BCA ASSESSMENT REPORT

GREYSTANES PUBLIC SCHOOL

February 2018

Rev 2

Figure 2: Second Floor Zone B

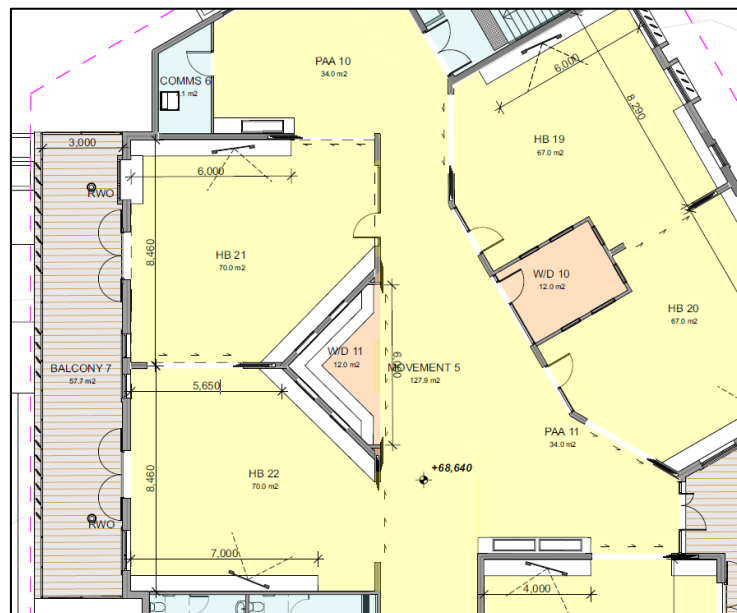
Note: areas in the Main building have sliding doors in the paths of travel to exits, and therefore need to be addressed for appropriate door hardware and door furniture. See D2.21 below for further information.

Figure 3: Ground Floor Zone B

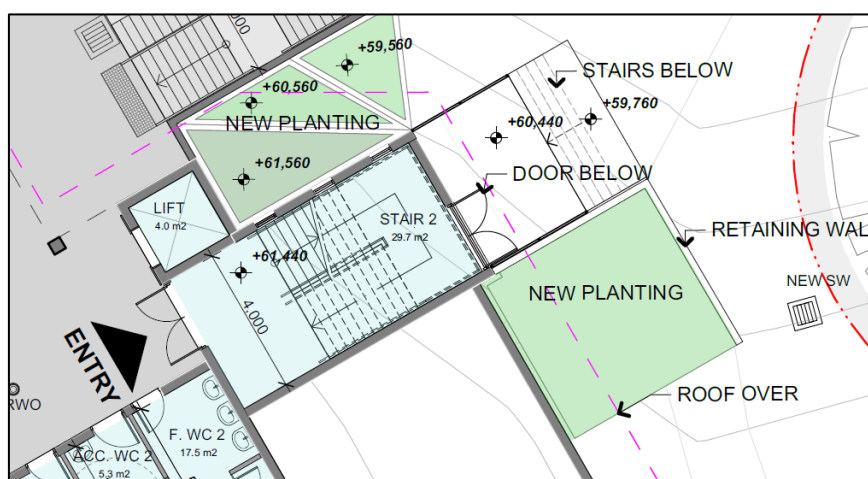
In this instance, the current design indicates compliance is achieved, noting that the stair discharges directly to open space at a half level below directly to open space.
